Your Ref
AL/32/18/PL
Our Ref
PLAN-022356
Date
19/04/2018

**Proposal: Erection of 1 No. single storey building. This applicaiton is a
Departure from the Development Plan.**
Site: Physiotherapy Clinic The Wolds Fontwell Avenue Eastergate PO20 3RU.
AL/32/18/PL

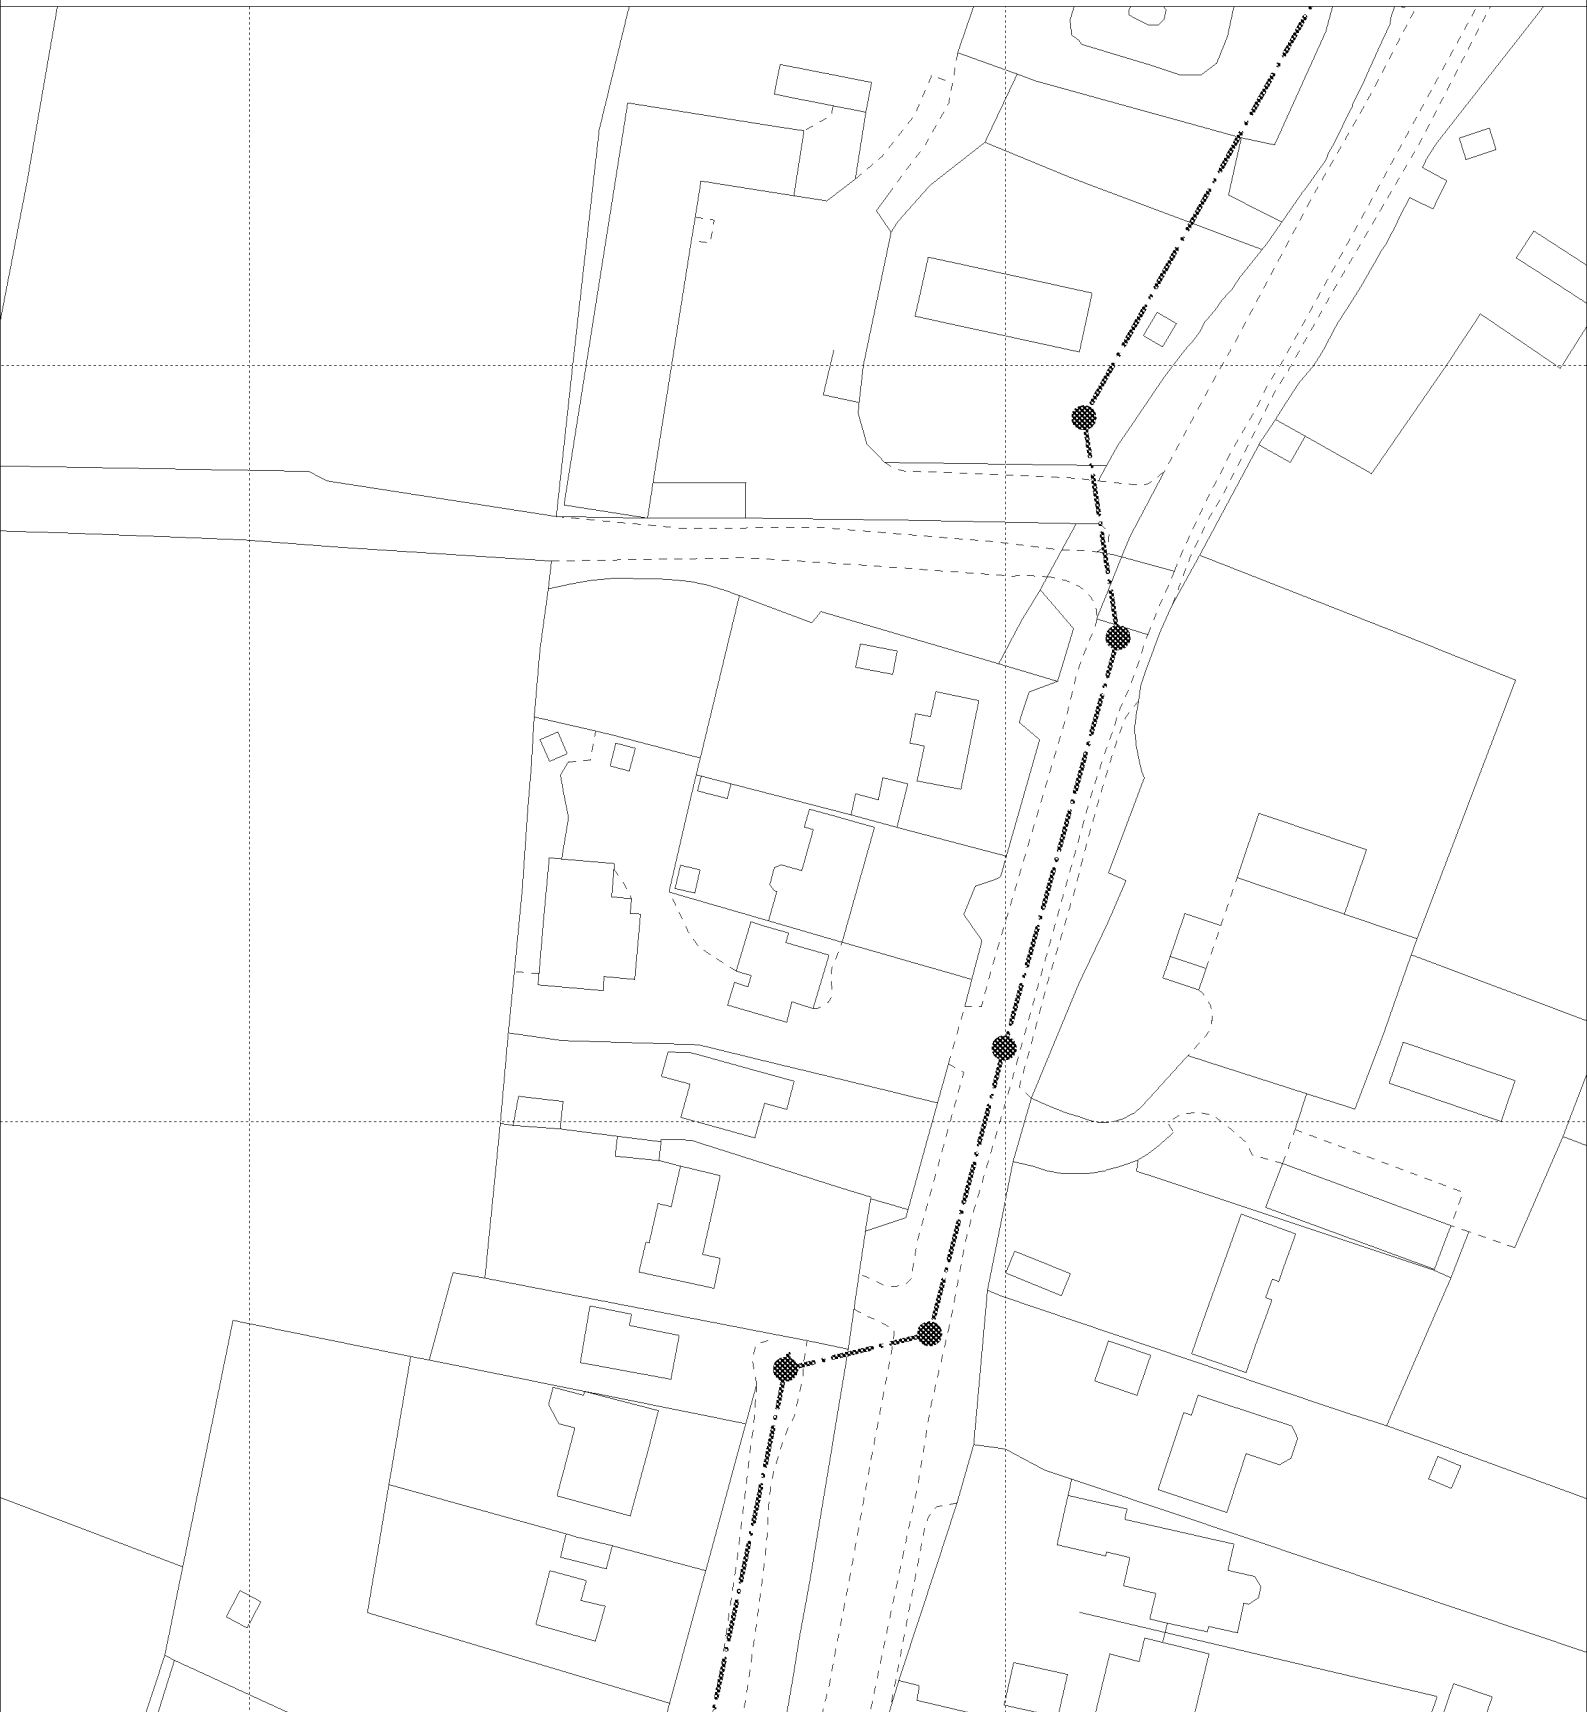
Due to surface water inundation issues in the Lidsey Catchment "The applicant is advised to adopt, where appropriate, the measures in the table "Practical measures to reduce the potential impacts of development".

Developer should look to protect the public sewerage system from inundation and infiltration, which contribute to flooding in unfavourable conditions.
